BL
53

Case Number: 2014-079972 PR
ADDRESS: 905 Columbus Street
Contact: Daniel Word, 974-3341
Public Hearing: October 1, 2014
Residential Design and Compatibility Commission

B/57

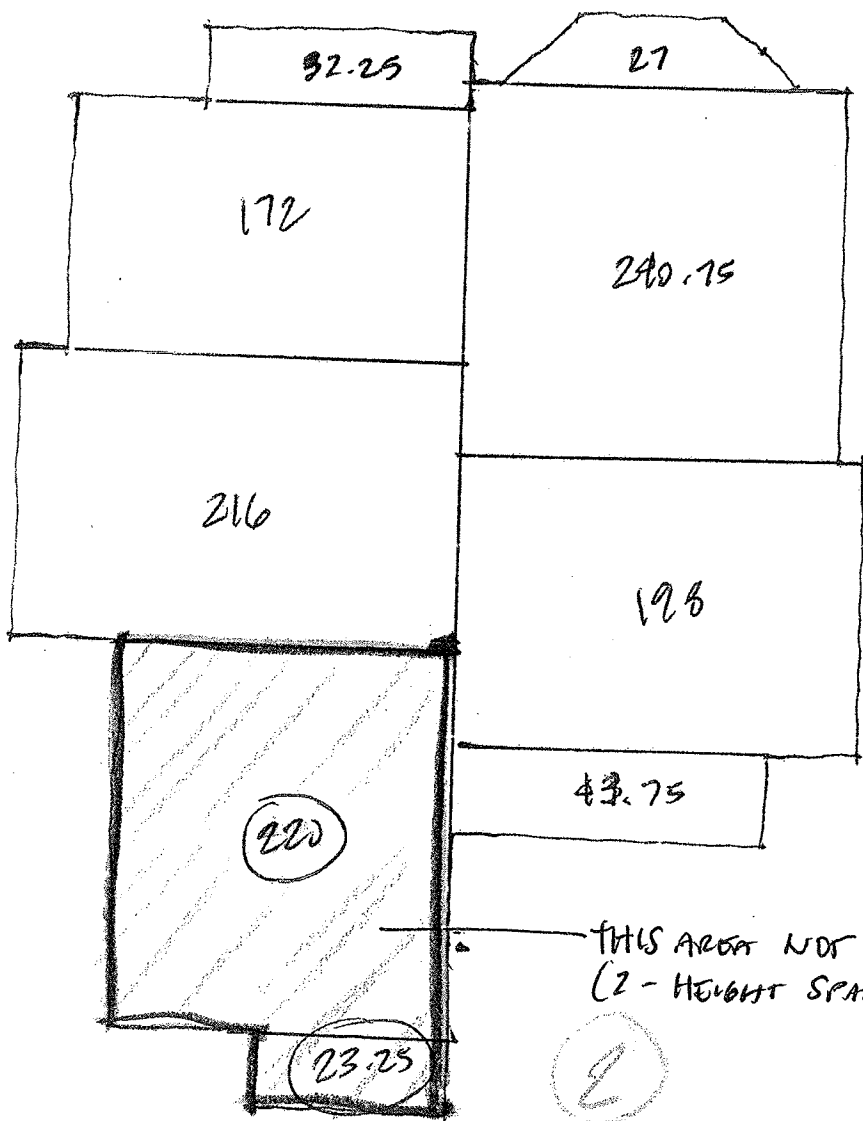
FAILED TO COUNT THE DOUBLE-HEIGHT SPACE OF THE FRONT ENTRY / STAIRWELL, WHICH WOULD INCREASE THE EXISTING HOUSE

AREA BY APPROXIMATELY 220-240 SF., IN ADDITION TO THE GARAGE MODIFICATION REQUESTED.

AREA IN RED SHOULD BE COUNTED 2X
(CEILING OVER 15' TALL)

> THIS AREA WAS NOT COUNTED IN SQUARE
FOOTAGE OF ORIGINAL PERMIT APPLICATION.

B/
59

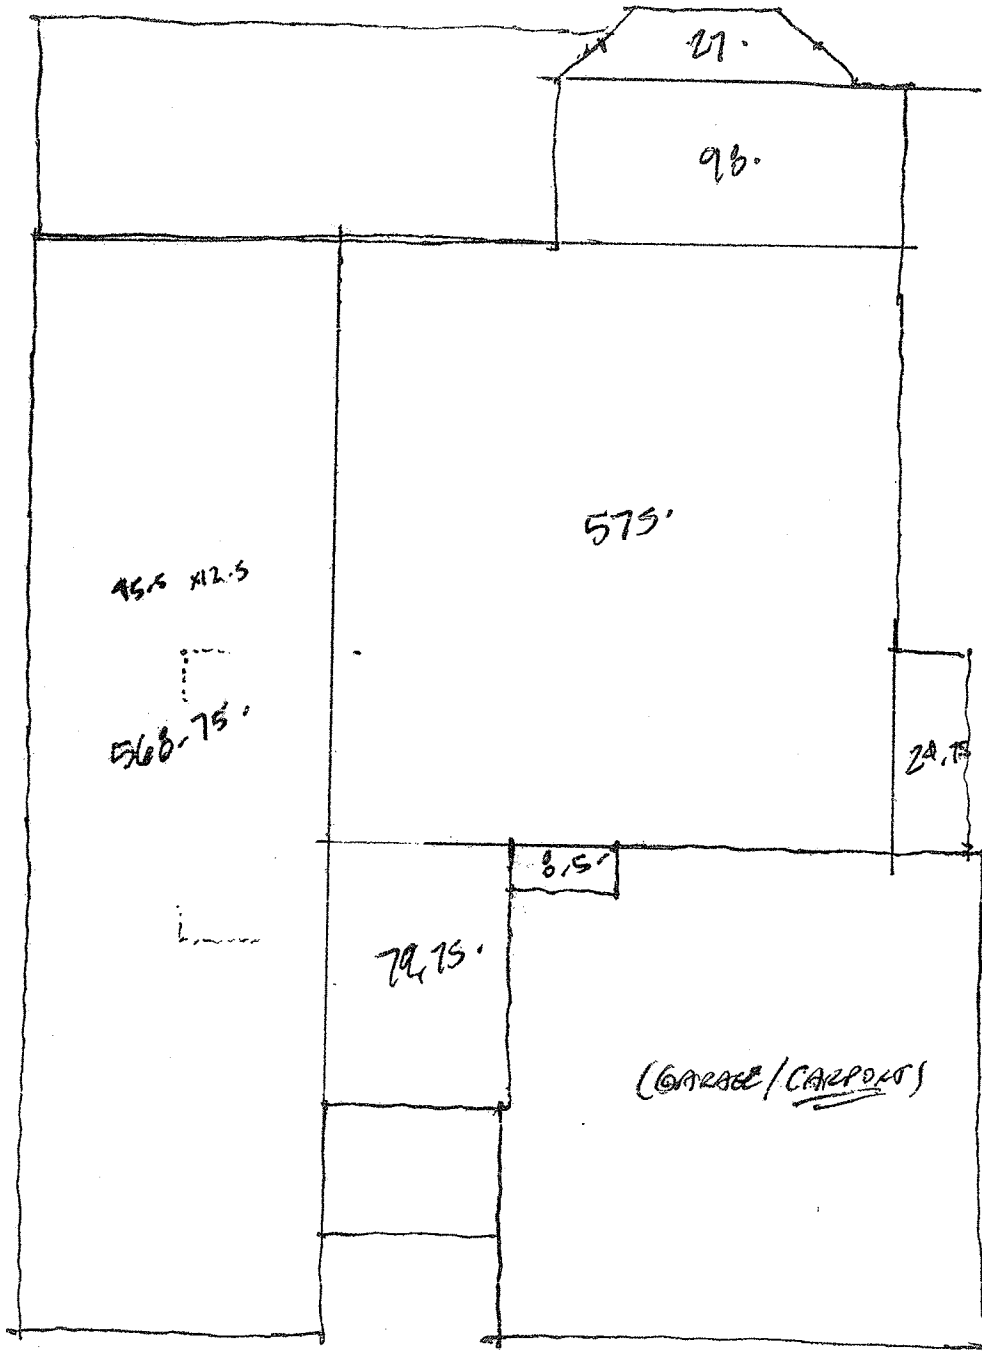
MG 899.75 (845)
+ 243.25 (220)
1143 (1073)

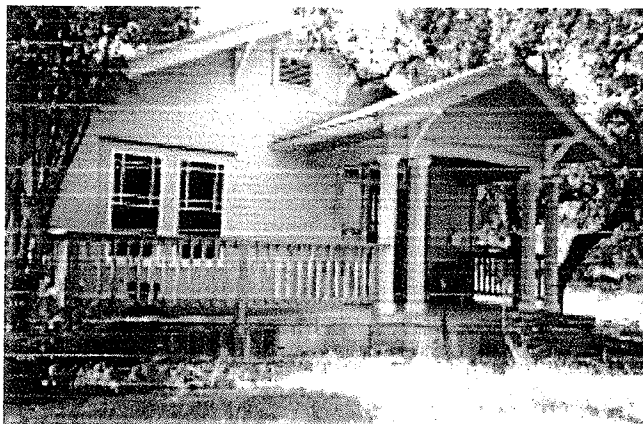
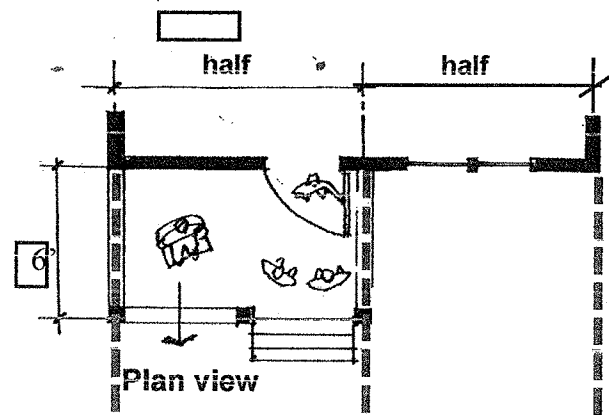
Guideline 1.4: Garages or carports are not common in the neighborhood but where they exist, they are detached and located at the rear of the lot. If an attached garage is desired, setting it back at least 10 feet from the front facade of the house will help to preserve the people-oriented character of the streetscape. Garages are typically designed to resemble the house in shape, material and color.

Modest houses have half the front space to sit
